REMARKS

Docket No.: W0583.70013 US00
Date: March 29, 2004
x03/28/04

Fig 3

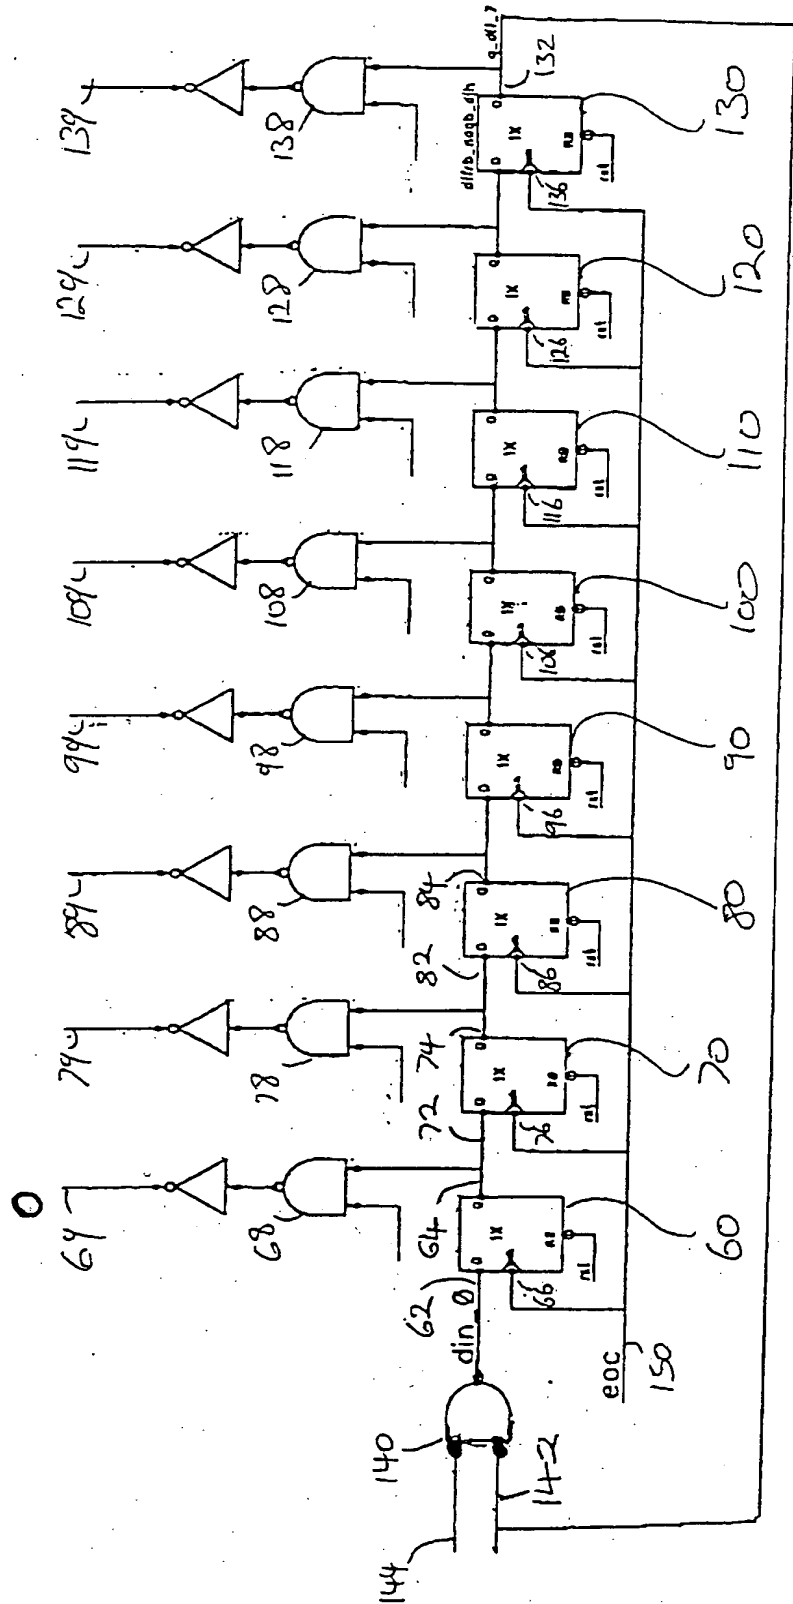
With respect to Figure 3, the Examiner requests that it be designated as Prior Art. An appropriate amendment to Figure 3 is proposed herein.

"PRIOR ART"
